**SOLICITATION AMENDMENT  
MODIFICATION DE L'INVITATION**

<b>Title - Sujet</b> Bâtiment d'entretien de l'équipemen	
<b>Solicitation No. - N° de l'invitation</b> EZ899-181343/A	<b>Amendment No. - N° modif.</b> 003
<b>Client Reference No. - N° de référence du client</b>	<b>Date</b> 2017-11-21
<b>GETS Reference No. - N° de référence de SEAG</b> PW-\$PWY-022-8224	
<b>File No. - N° de dossier</b> PWY-7-40239 (022)	<b>CCC No./N° CCC - FMS No./N° VME</b>
<b>Solicitation Closes - L'invitation prend fin</b> <b>at - à 02:00 PM</b> <b>on - le 2017-11-29</b>	<b>Time Zone</b> <b>Fuseau horaire</b> Pacific Standard Time PST
<b>F.O.B. - F.A.B.</b> <b>Plant-Usine:</b> <input type="checkbox"/> <b>Destination:</b> <input checked="" type="checkbox"/> <b>Other-Autre:</b> <input type="checkbox"/>	
<b>Address Enquiries to: - Adresser toutes questions à:</b> Arthur (PWY), Carolyn	<b>Buyer Id - Id de l'acheteur</b> pwy022
<b>Telephone No. - N° de téléphone</b> (604) 364-2752 ( )	<b>FAX No. - N° de FAX</b> (604) 775-6633

This amendment 003 is raised to:

PROJECT: PORT HARDY AIRPORT EQUIPMENT  
MAINTENANCE BUILDING

DRAWING NO:  
**AE-01 - ESK-09**

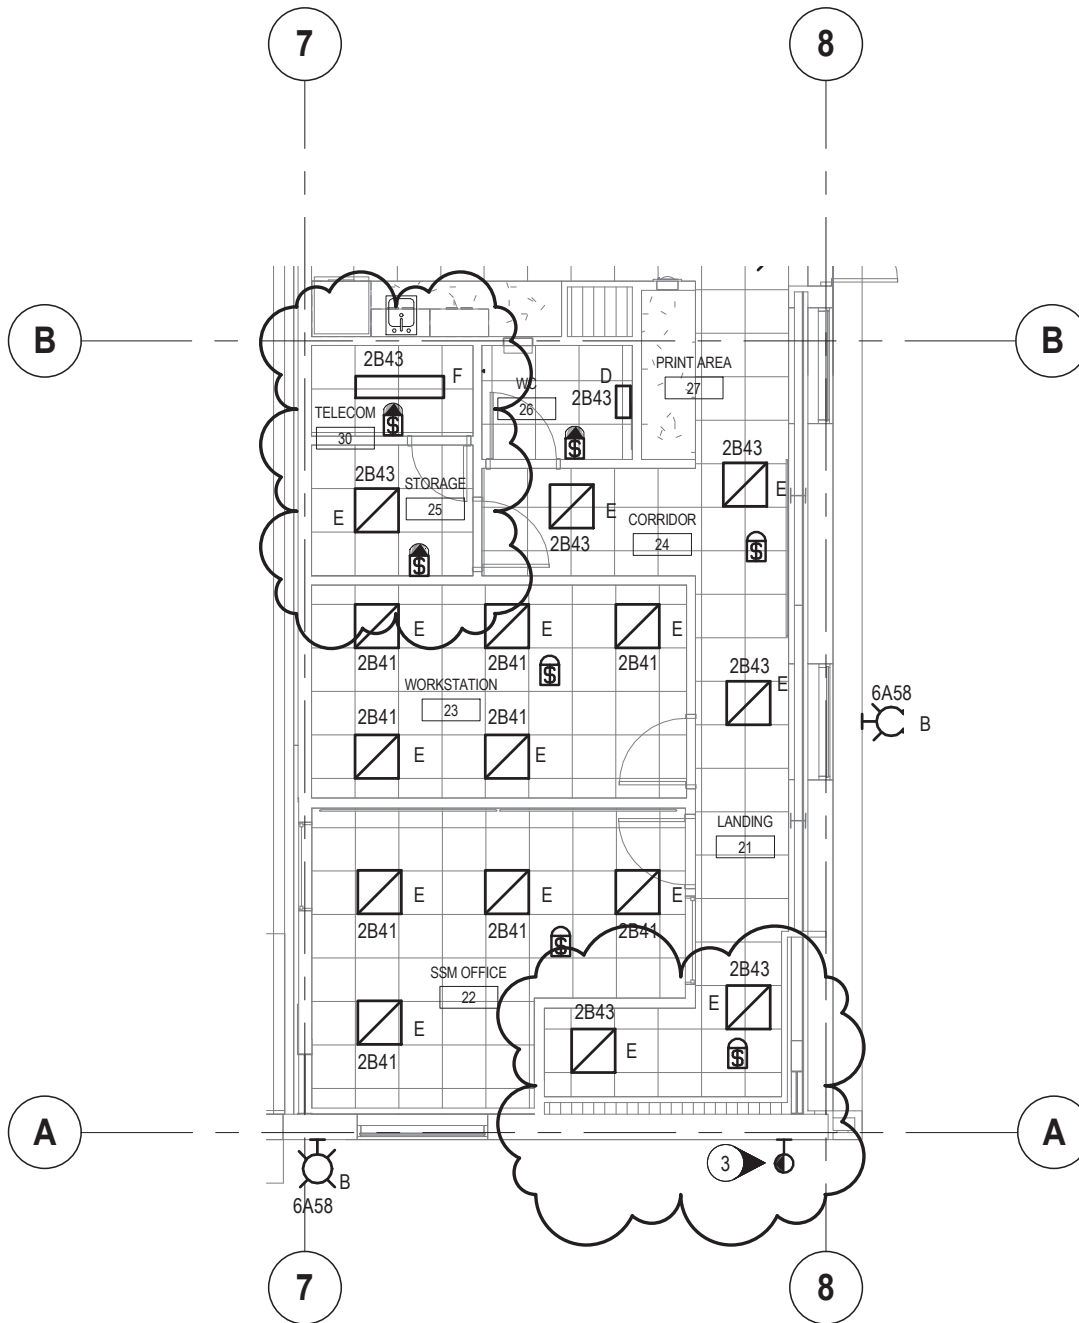
.1 Refer to electrical sketch ESK-09 and ESK-10 for floor lighting revisions;

.1 WC 05 luminaire type D

.2 Lighting control added for Shower 09, Storage 25 and Telecom 30.

.3 Added a type E fixture for stairs.

.4 Break room 07 light switch to be occupancy sensor.

.5 Photocell added for exterior lighting controls.
